**TOWN OF SUMMERVILLE
DESIGN REVIEW BOARD – AGENDA
Summerville Municipal Complex
Summerville Council Chambers or Zoom Virtual Meeting
September 17, 2020 4:00 p.m.**

Design Review Board Minutes
Thursday, August 20, 2020
Zoom Virtual Meeting

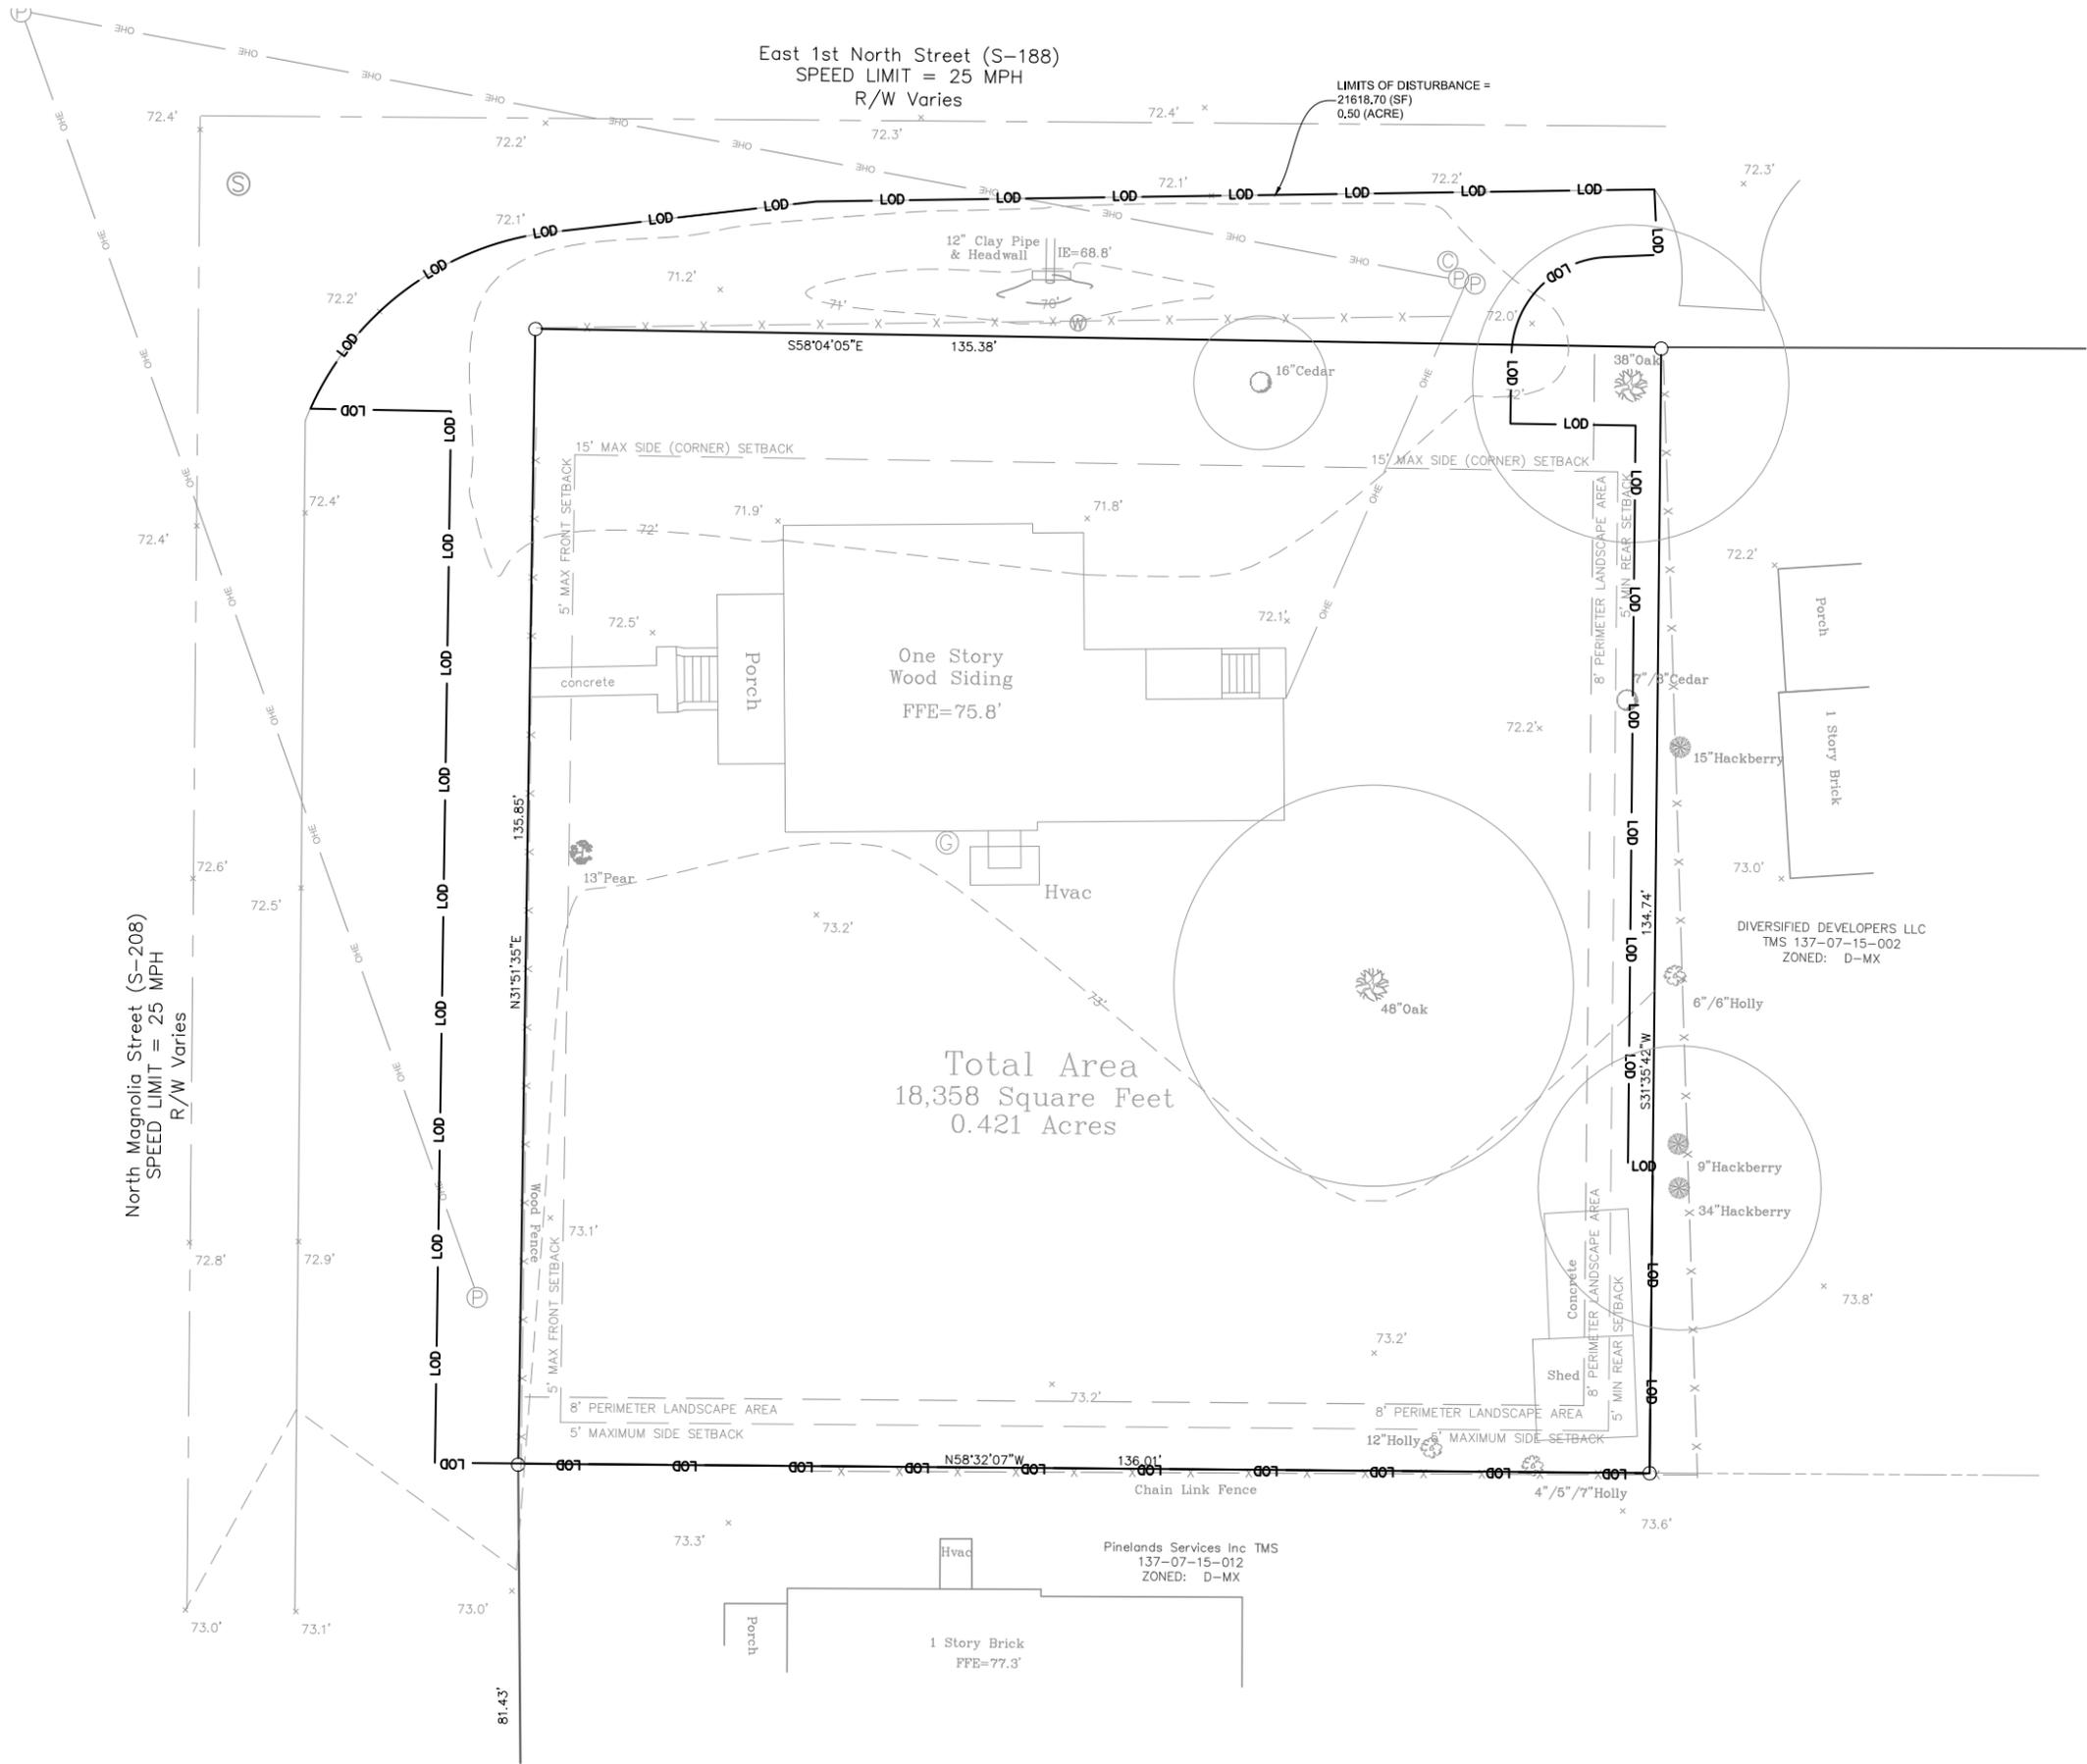
Based upon staff review the following comments must be addressed to meet requirements. The proposed impacts into the critical root zone of the 48" oak may need Tree Protection Board (TPB) approval. Consider requesting angled parking on N. Magnolia St. A pedestrian connection must be made into the site. Sidewalks along the right-of-ways are technically required per UDO Section 5.3.1 and 5.3.2. Town Staff may waive this requirement depending on the circumstances. This requirement will be considered as more detailed plans are completed based on existing conditions and feasibility. A full Landscape Plan, Signage Plan, and Photo Metric Plan have not been submitted. The Ground Floor does not meet the 65% transparency requirement of Section 4.2.9 A. The building provides a mixture of exterior finishes, including vertical shiplap siding and brick.
